TITLE - DOOR AUTOMATION

DWG NO - NTPL- 327

PRODUCT - MOTORIZED ROLLING SHUTTER

PROJECT NO - NTPL- 327 | REVISION - 00

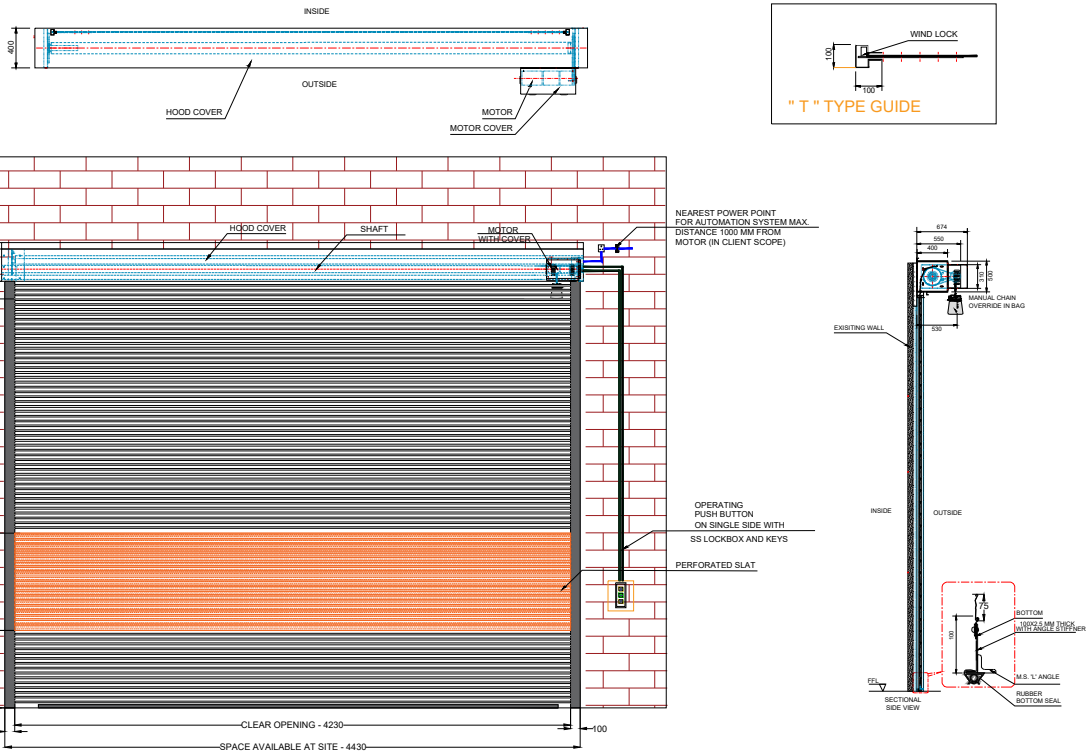
CONSIDERING THE LARGE DOOR SIZE (7400X4240 MM) & THE INCREASED CLEAR HEIGHT,THE DOOR WILL BE EXPOSED TO HIGHER WIND PRESSURE.TO ENSURE SAFE,SMOOTH,& RELIABLE OPERATION OVER ITS SERVICE LIFE, THE FOLLOWING MEASURES ARE RECOMMENDED:

1) PERFORATED SLAT IS RECOMMENDED BETWEEN THE SHUTTER TO PROVIDE ADDITIONAL STRENGTH & STABILITY DOOR.
2) SAFETY CATCH ARRANGEMENT NEED TO CONSIDERED TO PREVENT ACCIDENT IN CASE OF FAILURE IN DRIVE SYSTEM, ENSURING MAXIMUM SAFETY TO PERSONNEL & EQUIPMENT.
